Our ref: PS118400-P&M-LTR-011 Request for Additional Info

Health Infrastructure engaged WSP to prepare a Transport Assessment (TA) as part of an Environmental Impact Statement (EIS) for inclusion in a State Significant Development Application (SSDA) for the Children's Hospital at Westmead Redevelopment Stage 2, Paediatric Services Building. The TA (March 2021) assessed the traffic, car parking and loading requirements of the proposal.

RESPONSE TO SUBMISSIONS – TRAFFIC AND TRANSPORT

Figure 1 PSB Level 02 off-street car parking

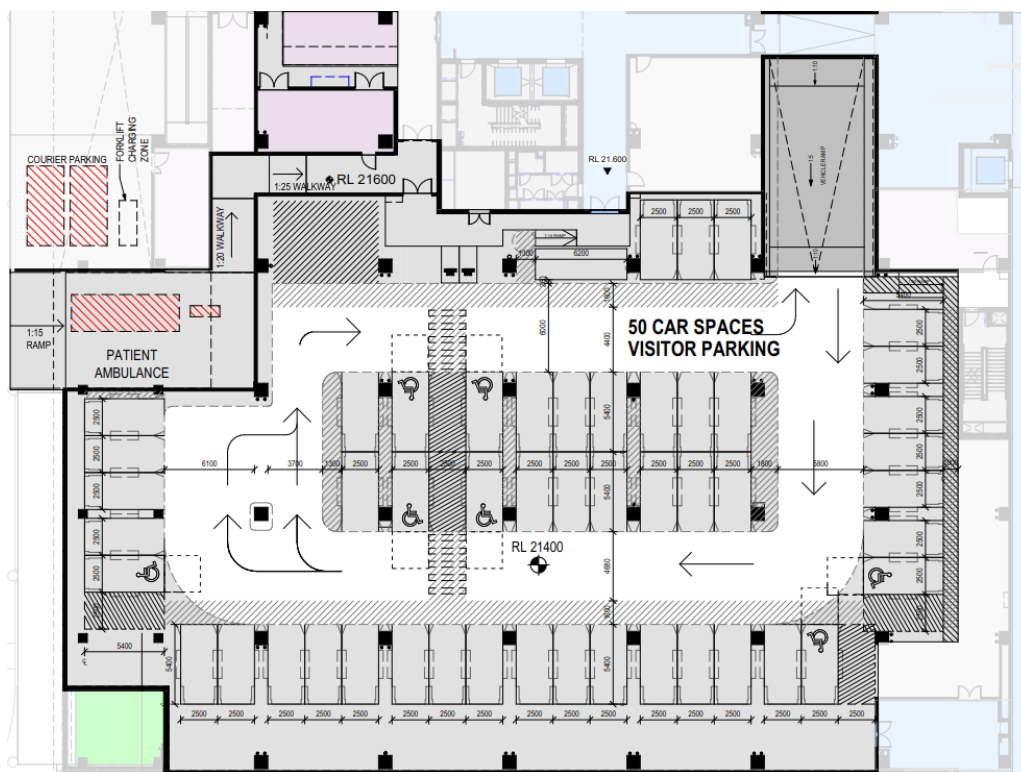
It is recommended that the plans be revised to provide shared areas for disabled parking spaces that is compliant with AS2890.6-2009. Note that bollards are to be installed in accordance with Figures 2.2 and 2.3 of AS2890.6-2009. Furthermore, it is also recommended that plans be revised to include directional pavement arrows/signs to indicate the one-way traffic flow within the car park.

As depicted in the image below, shared areas with complying dimensions have been provided for car parking spaces for people with disability. Additionally, the traffic circulation within the car park has been indicated to be one-way in the clockwise direction.

Bollards in the shared area and pavement arrows can be readily included in the car park layout to comply with the Australian Standards (AS2890.1 and AS2890.6 for off-street car park and off-street parking for people with disability respectively).

Figure 4 Active and public transport infrastructure

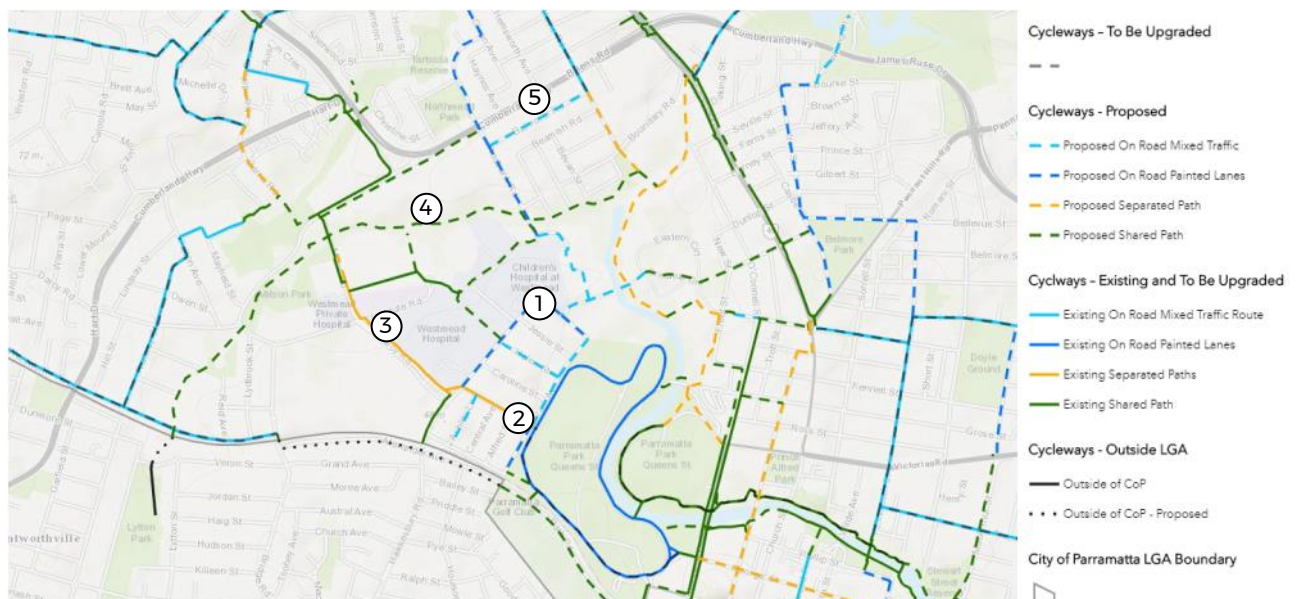
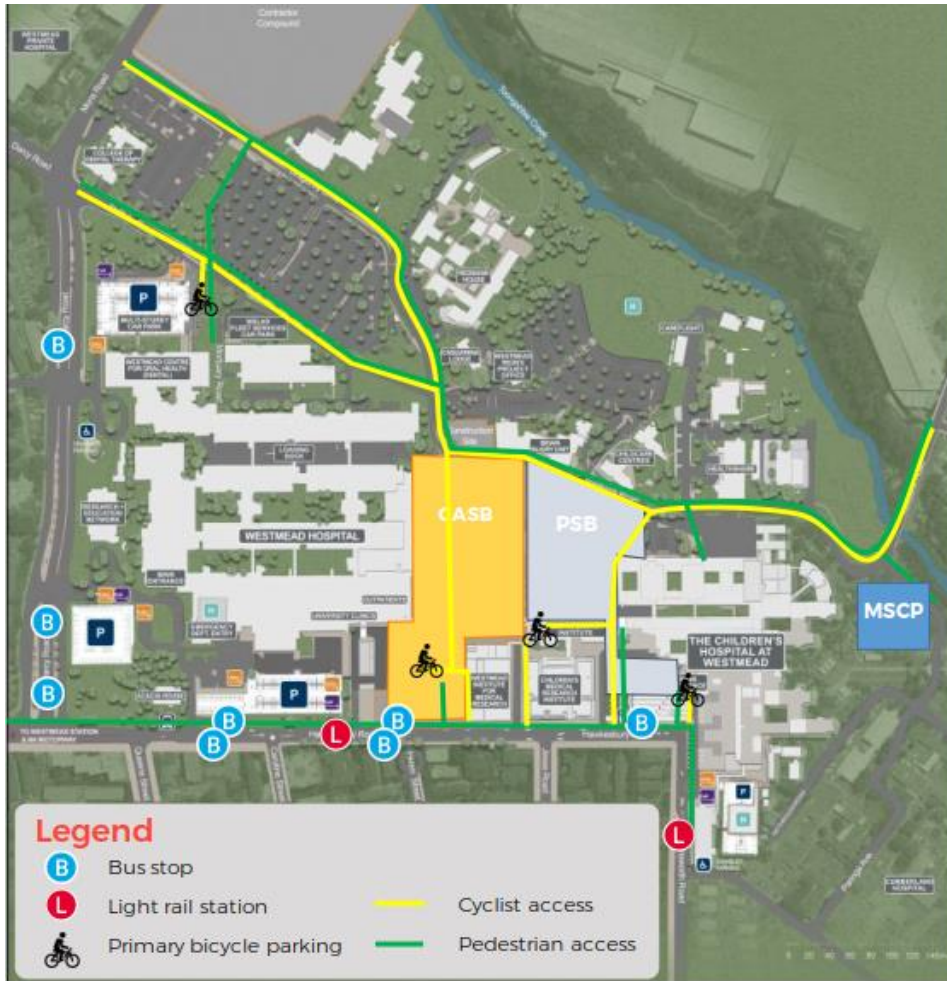
The Transport Assessment report makes limited commentary and recommendations for improving links to the surrounding pedestrian and cycle networks. This is considered necessary to achieve mode shifts to public and active transport. The preliminary GTP and Transport Assessment report make no assessment of surrounding pedestrian and cycling infrastructure to access the site.

Further, the proposed pedestrian connections between the PSB and public transport (indented bus bay along the frontage of the site and “Children’s Hospital” light rail stop on Hainsworth Street via the pedestrian crossing on Hawkesbury Road) via the proposed KIDSPARK are indirect.

Pedestrian access between CHW and the surrounding public transport network and the surrounding active transport network would be via the Hawkesbury Road footpath. Within this site, Kidsway would facilitate this safe pedestrian access. Externally, current and future pedestrian crossing facilities will be provided along Hawkesbury Road to accommodate safe access to and from the Station and stops.

These routes are the most direct routes connecting the PSB to public transport network.

ATTACHMENT C
**LOADING DOCK HRV (SIDE-
LOADING) BAY SWEEP PATH**

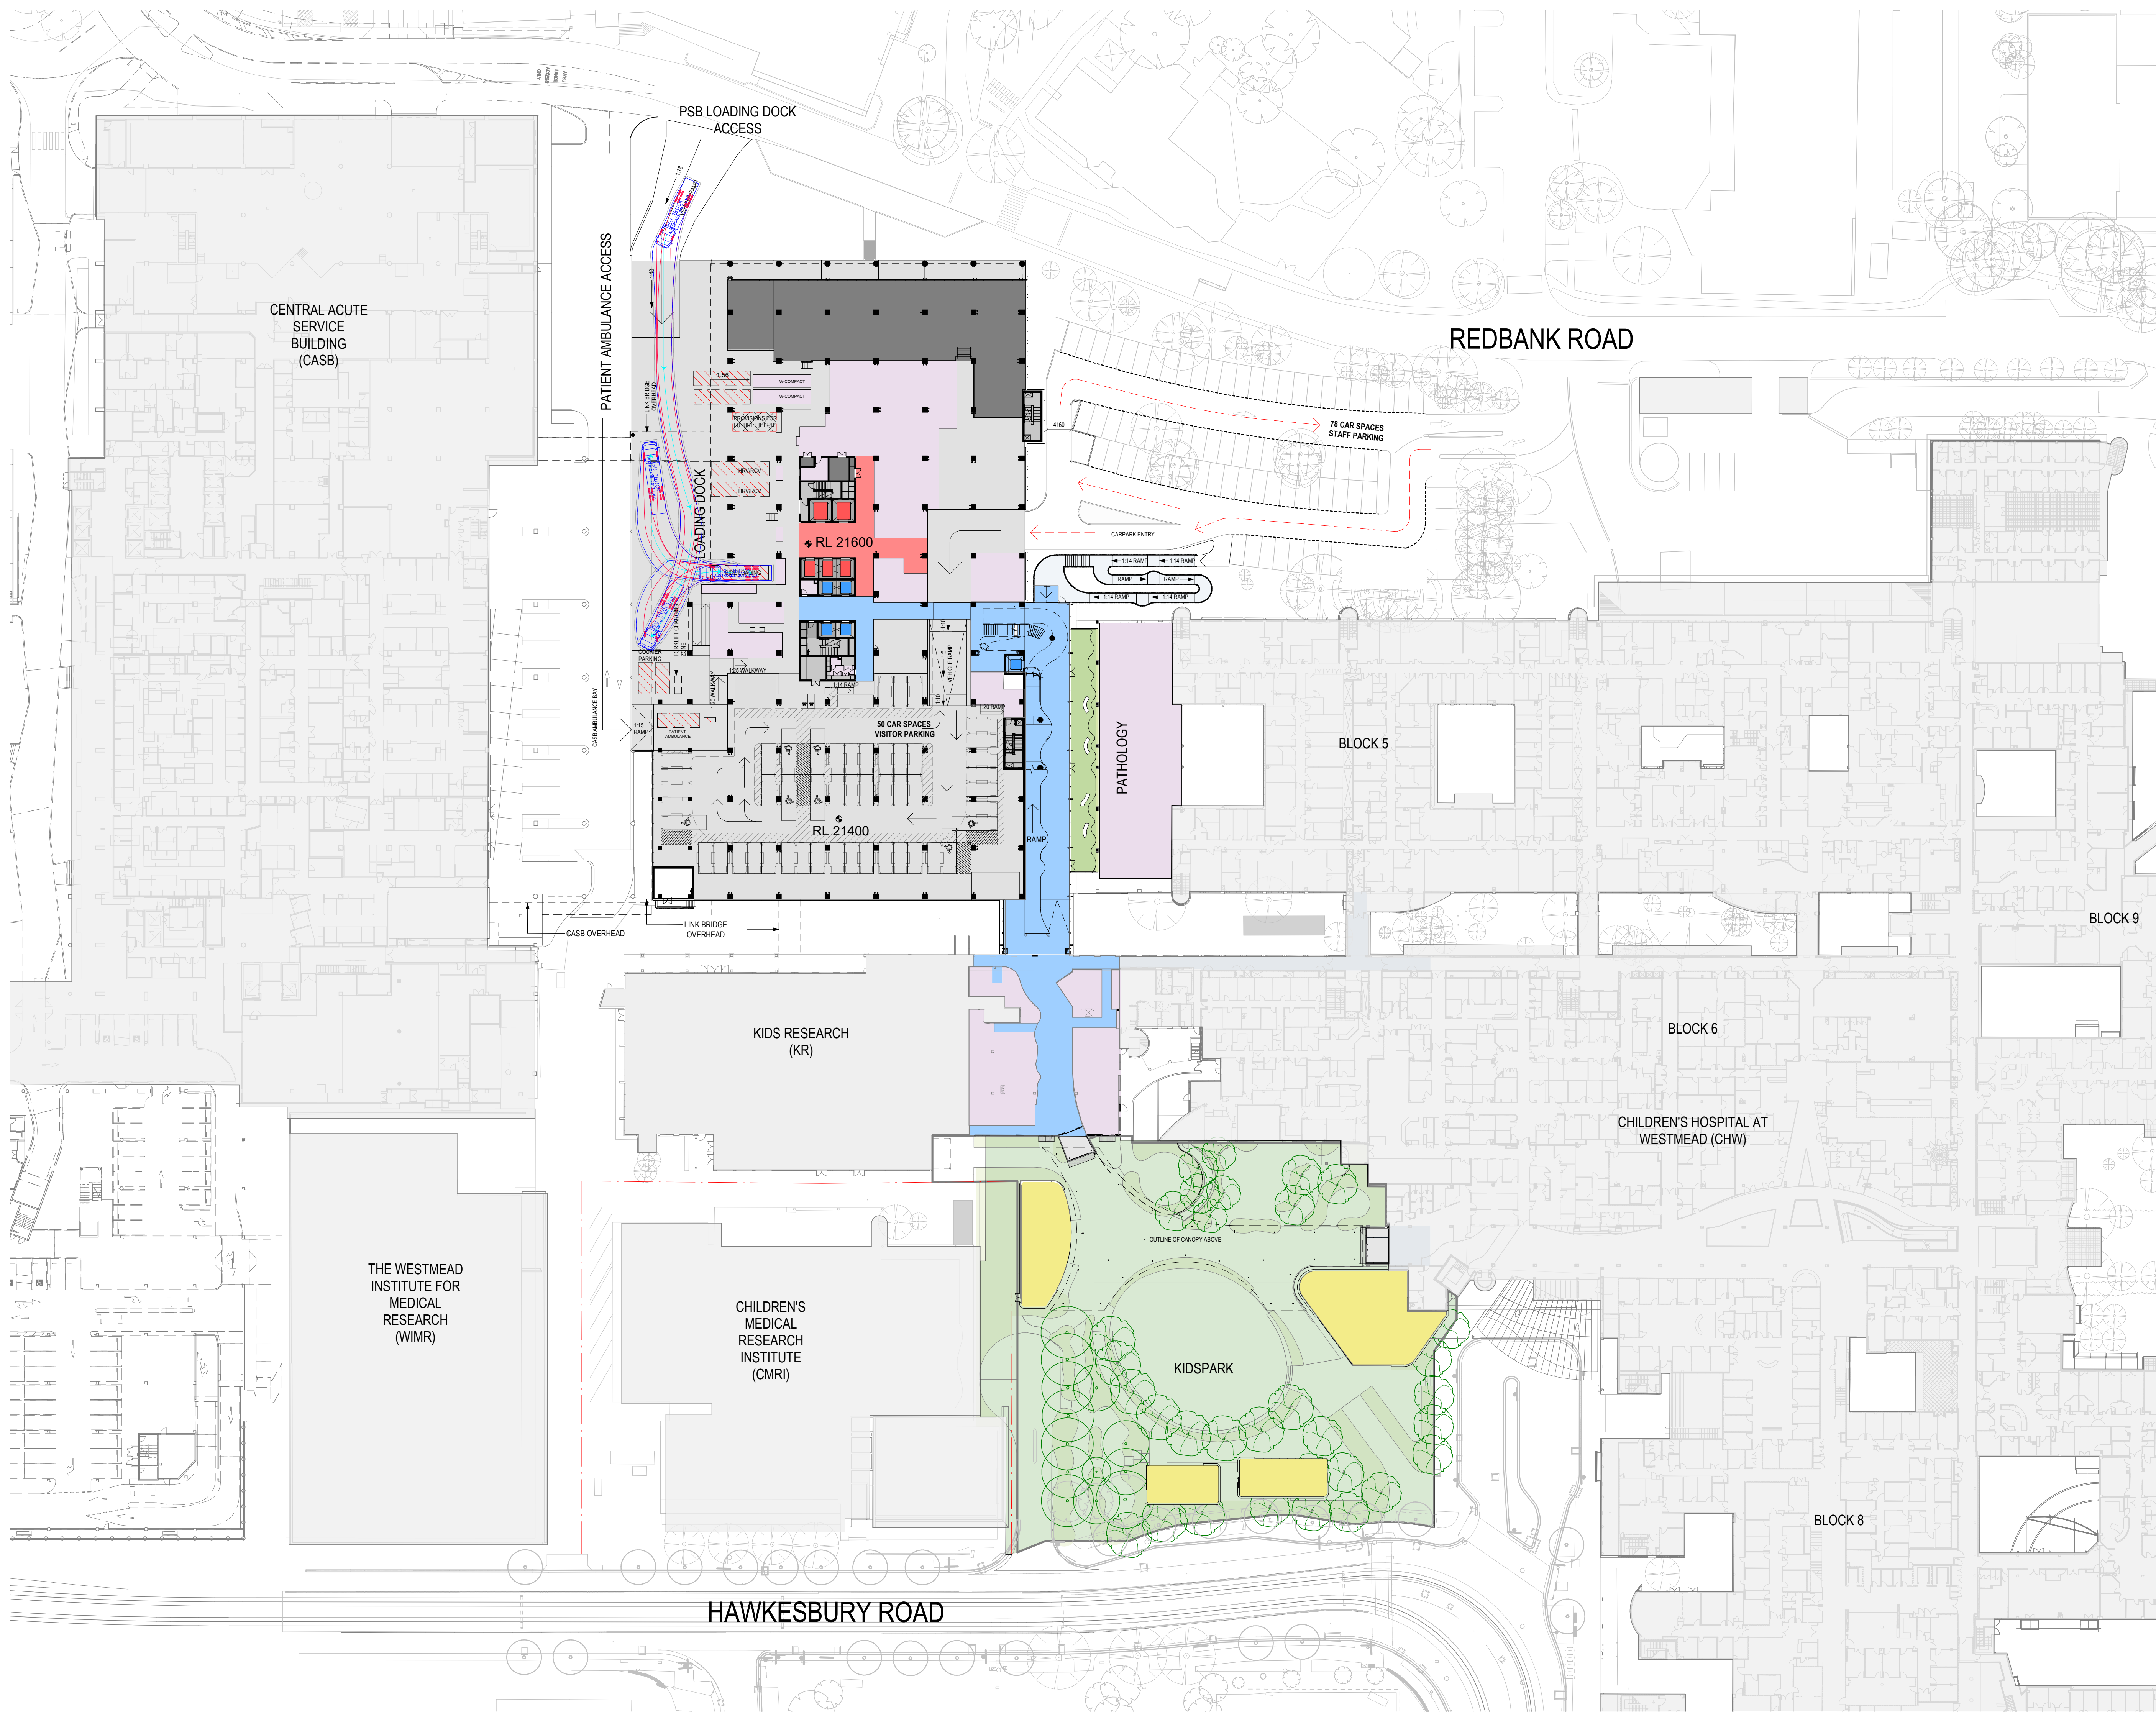
9. Swept path plans for the loading dock have been provided and indicate that on-site manoeuvring for vehicles accessing the HRV, Substation Maintenance bays and Compactor bays require certain spaces to be unoccupied and at times, utilise the full width of the driveway/ramp in order to park the vehicle rear to kerb. It is unclear how the spaces will remain unoccupied, how the trucks will be coordinated within the loading dock and who will have priority should there be vehicles (particularly HRVs)

wanting to enter and exit the facility simultaneously. Therefore, a Loading Dock Management Plan should be provided and reviewed to address these concerns.

However, it is recognised that per the plans submitted as part of SSDA lodgement, on-site manoeuvring for vehicles accessing the HRV (side-loading), Substation Maintenance bays and Compactor bays require certain spaces to be unoccupied, and that vehicles exiting the loading dock in a left-out manner may conflict with vehicles entering the loading dock.

Design changes since SSDA lodgement have shifted the courier bays to the south to enable the side-loading dock to be accessed without affecting the courier spaces. As such, all HRV bays can operate independently. The swept path plan for the HRV (side-loading) bay is shown in Attachment C.
